**TEXAS COMMISSION ON ENVIRONMENTAL QUALITY**  
**AGENDA ITEM REQUEST**  
**for Adoption of an Agreed Order**

**CAPTION: Docket No. 2011-0521-MIS.** Consideration of adoption of an Agreed Order with Exide Technologies (Exide) in Collin County to require Exide to install and implement control strategies for lead emissions as part of the Collin County Attainment Demonstration State Implementation Plan (SIP) Revision for the 2008 Lead National Ambient Air Quality Standard (NAAQS). The Agreed Order also includes contingency measures that are required by the Federal Clean Air Act to be part of an attainment demonstration SIP revision.

**Subject:** Commission Approval for Adoption of Agreed Order for Exide Technologies Lead Acid Battery Recycling Plant in Collin County

**RESPONSE TO COMMENTS RECEIVED CONCERNING  
THE COLLIN COUNTY ATTAINMENT DEMONSTRATION  
STATE IMPLEMENTATION PLAN (SIP) FOR THE 2008  
LEAD NATIONAL AMBIENT AIR QUALITY STANDARD  
(NAAQS) AND AGREED ORDER BETWEEN THE TEXAS  
COMMISSION ON ENVIRONMENTAL QUALITY (TCEQ)  
AND EXIDE TECHNOLOGIES (EXIDE)**

**Attachment C**  
**Traffic Plan for Landfill**

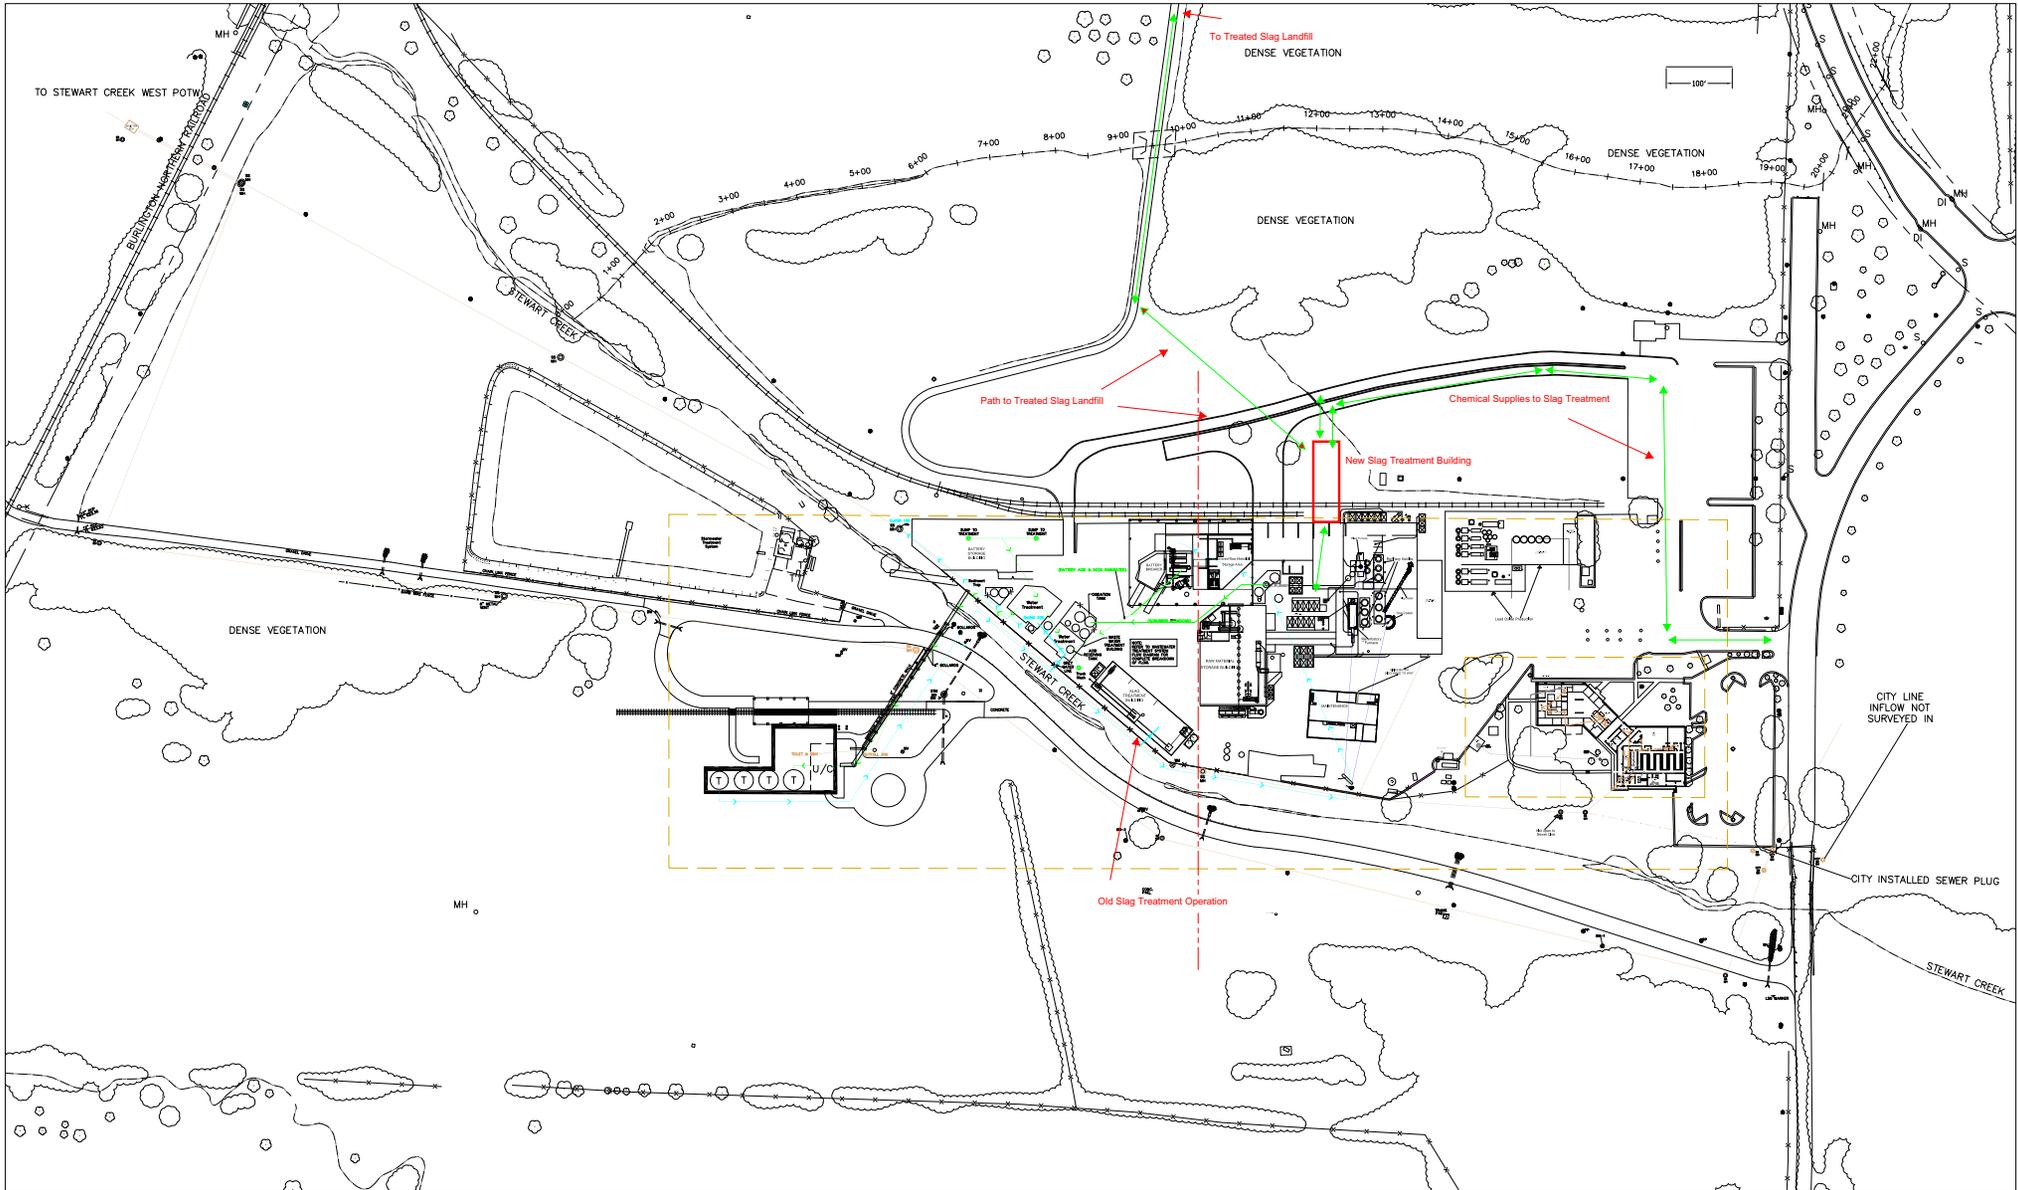
Exide commented that it has developed improvements to the traffic plan for truck traffic within the facility. Exide has provided a new traffic flow diagram to reflect those improvements and recommended that the new diagram replace the existing traffic flow diagram in Attachment C of the proposed Agreed Order.
